Comments re. Planning Application no. 2019/2601/P – 1 Glenhurst Avenue, NW5 1PT –

I am the freeholder of 3 Glenhurst Avenue, the adjoining property to the west of No.1 Glenhurst Avenue ('No.1 Glenhurst'). Since August 2009, there has been maintenance work done to the roof and to the exterior real wall (including window frames) of No.1 Glenhurst.

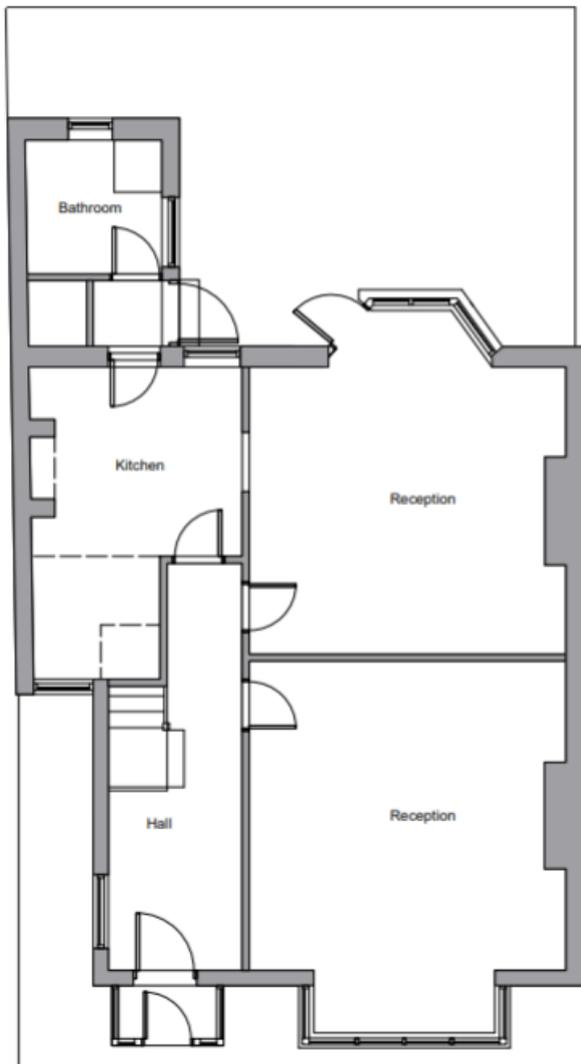
The following picture 4, under the heading 5. External Property 5.1 External Condition, of the DAHS described as ‘Existing rear condition in poor state of repair’ is, in fact, a picture of my property; 3 Glenhurst Avenue, and not of No. 1 Glenhurst. This picture has been included in error. The rear of my property is certainly not in a poor state of repair. I have already mentioned this to Thomas Sild, the planning officer, and he has noted the error and offered to redact the Application to delete this.

Figure 3b: Rear dormer window

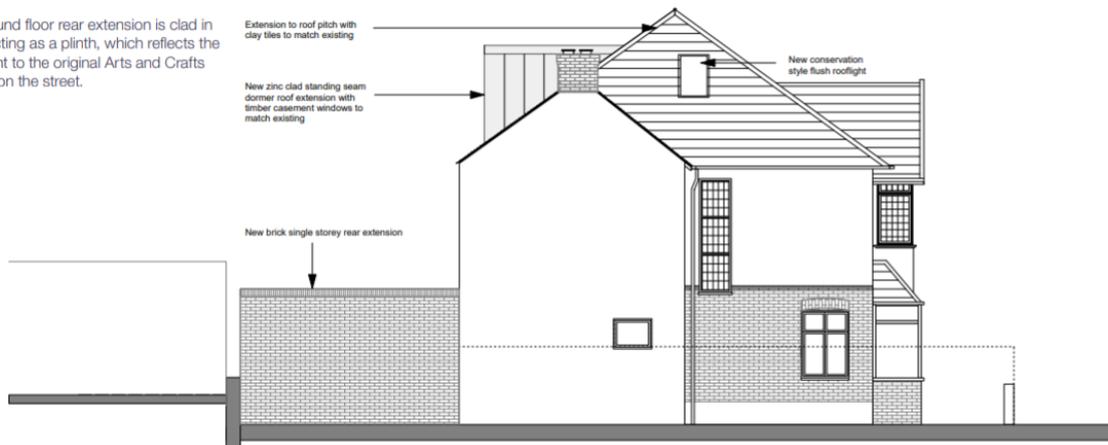
In Figure 3b, the structure surrounding the window is smaller both in height and width to the window below. In the current plan, the Dormer windows are the same width as well as being higher than the windows below, and the surrounding structure is both wider and higher. Furthermore, the above proposed drawing does not show the extent to which the Dormer protrudes from the roof. This is quite substantial, as shown by the proposed east elevation and the proposed section elevation. The proposed section drawing below has not been included in the DAHS. Both these drawings show the extent to which the proposed Dormer will dominate the host building to the east and to the west over the existing lower section of the roof at the front.

Proposed section drawing (omitted from DAHS):

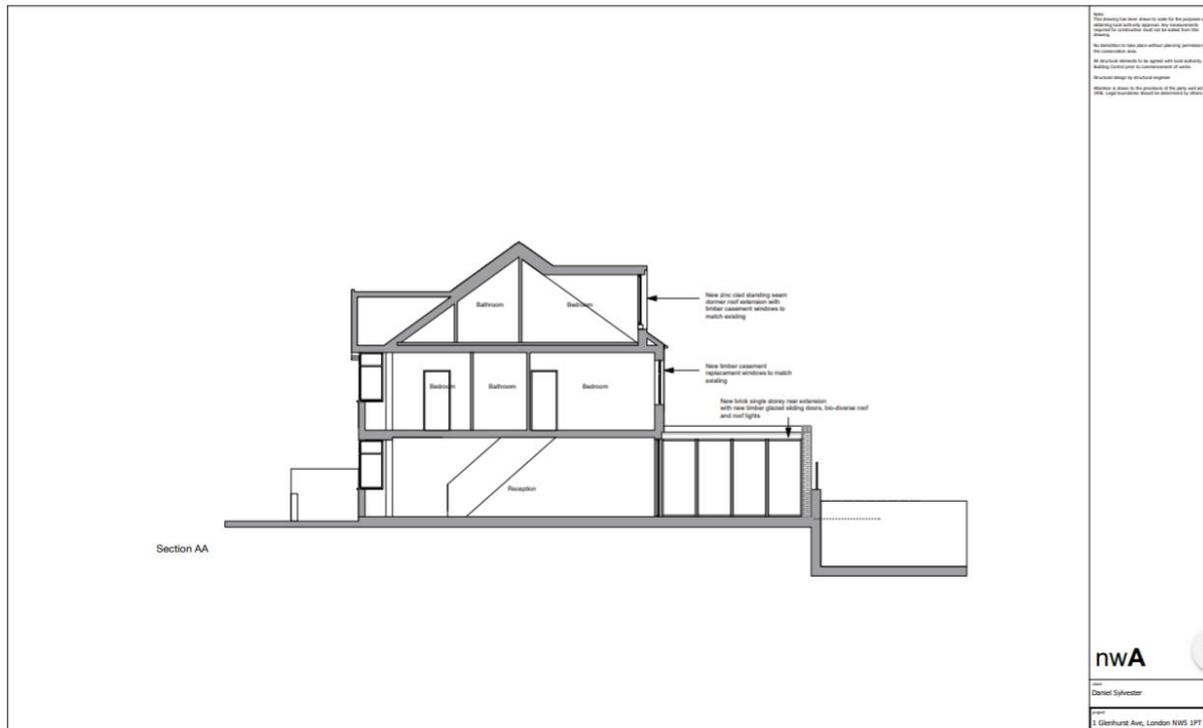
It is not necessary for the proposed Dormer to be of such a large scale/bulk, particularly in height: Under 'Design Principles and concepts' in 1 Executive Summary of the DAHS, it states 'the proposed development includes [...] and dormer to create a habitable en-suite bedroom in the loft.' However, most of the proposed Dormer will be where the existing roof is already of unrestricted height, as shown in the below drawings:

8 Existing Drawings

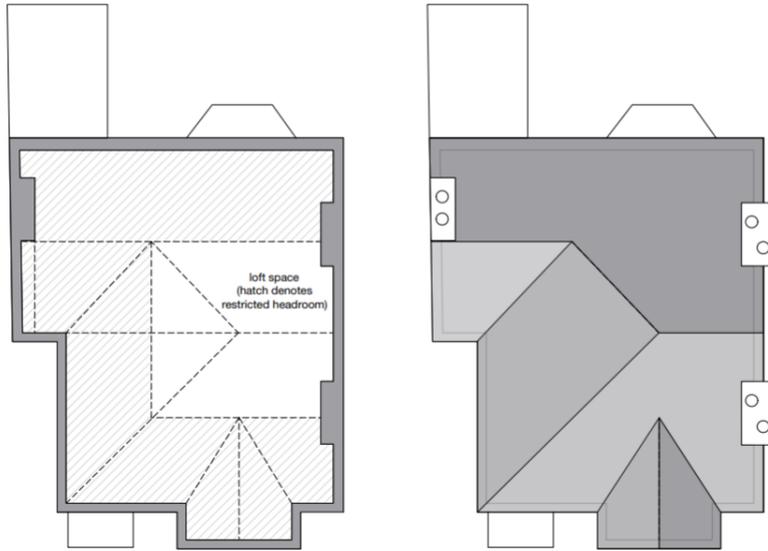
The existing loft has is approximately 3m high at the centre but has a relatively steep pitch angle, which deems over 2/3rds of the loft space uninhabitable.

9 Proposed Drawings

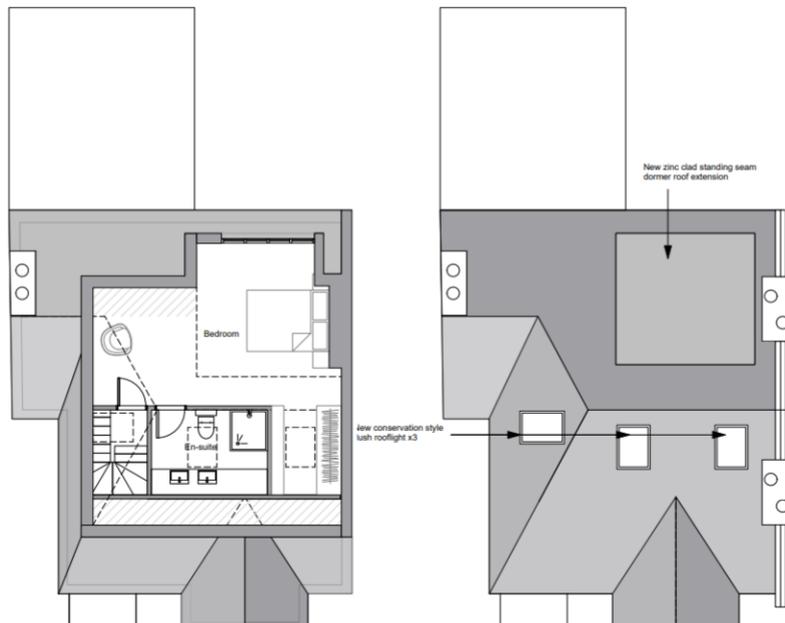
There are also 2 oblong shapes in the garden on the above proposed drawing plans 9.1 without any explanation of what these structures are, their material, and or height and what affect they will have on my outlook, privacy and amenity.

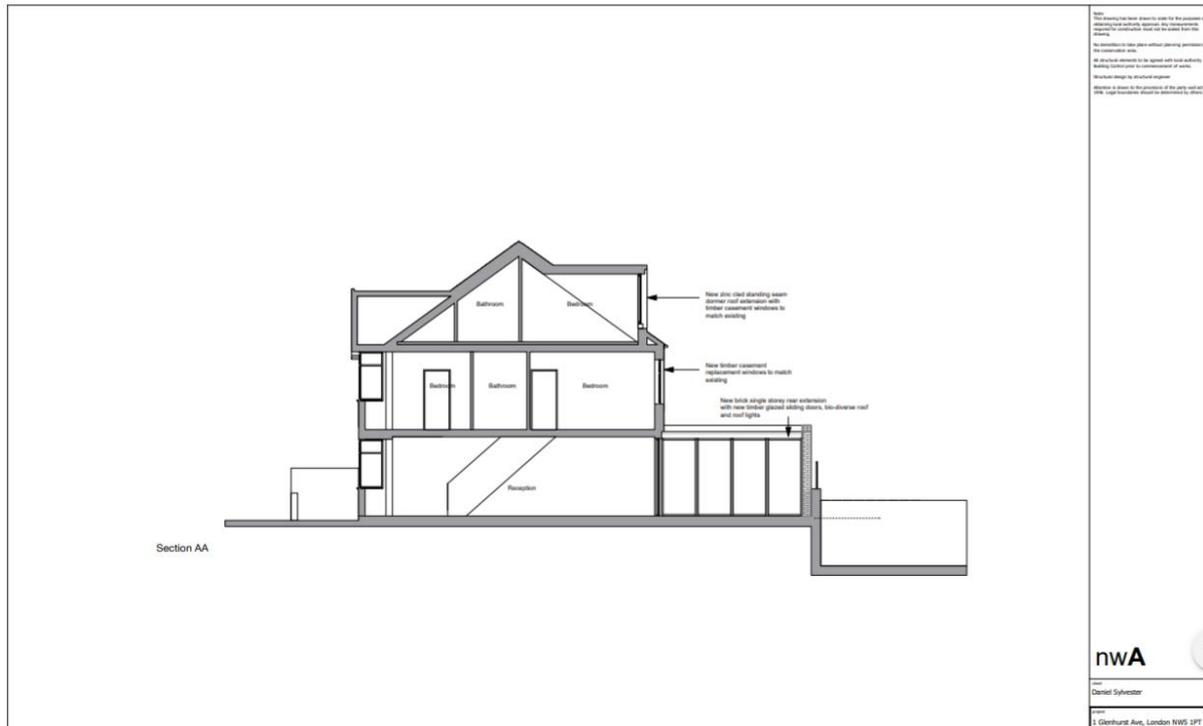
The proposed section drawing (not included in the DAHS) shows how the Dormer will adversely affect my Amenity as referred to above.

8 Existing Drawings

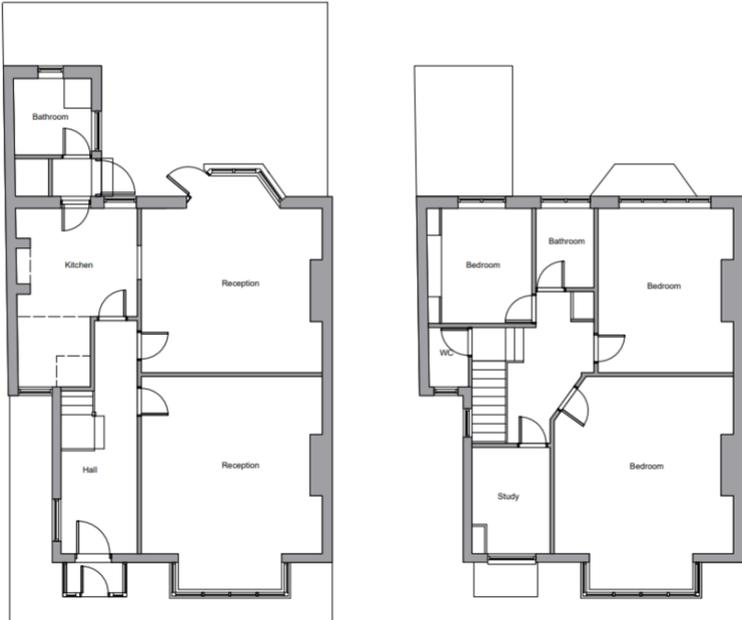
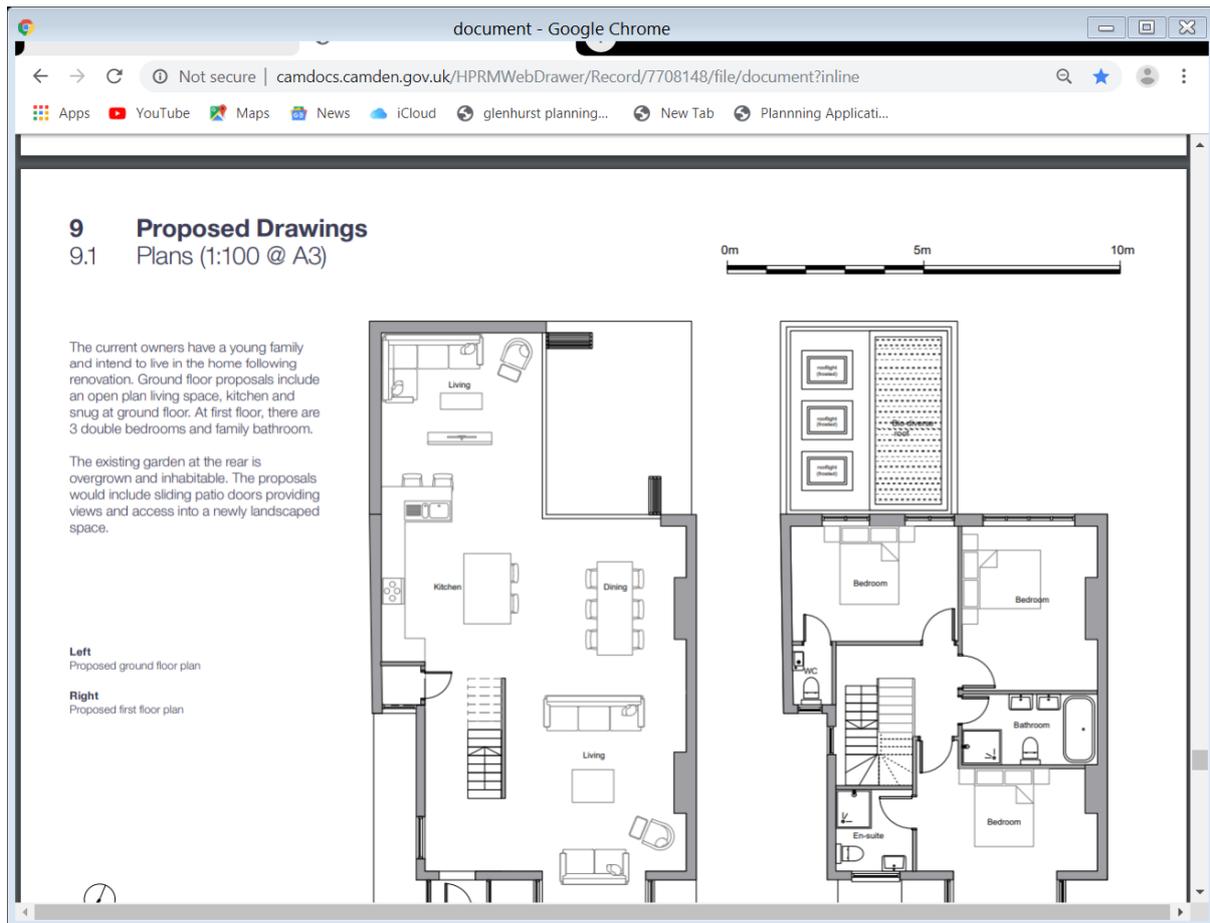
The existing and proposed drawings show how much nearer to my property the siting of the new Extension will be:

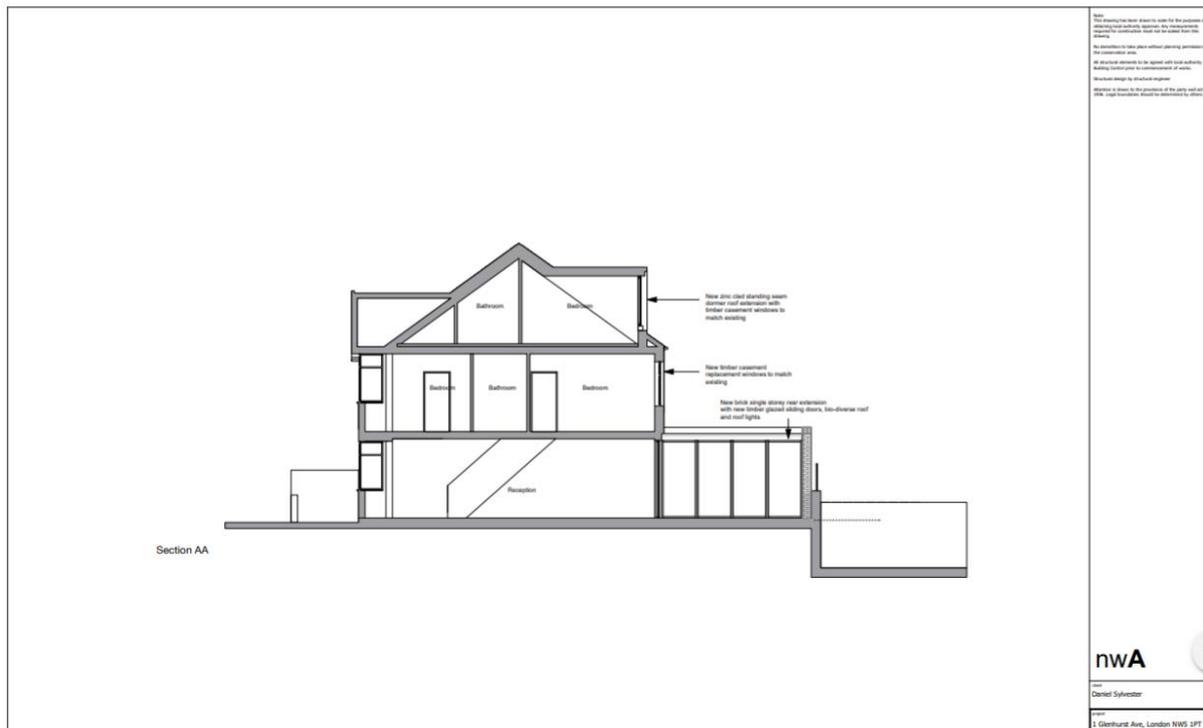
The proposed section drawing, (which, along with the existing section drawing, is not included in the DAHS), shows the height of the new Extension, (approx. 3 meters) and in particular, the height of the sliding doors. It also shows how much my garden will be overlooked by the full height sliding doors of the new Extension which will run along the full depth of the back garden of No.1 Glenhurst.

The modern sliding doors will be clearly visible close to my property. None of the design of the new Extension to the west with its sliding doors reflects any Arts and Crafts principles or any interpretation of them.
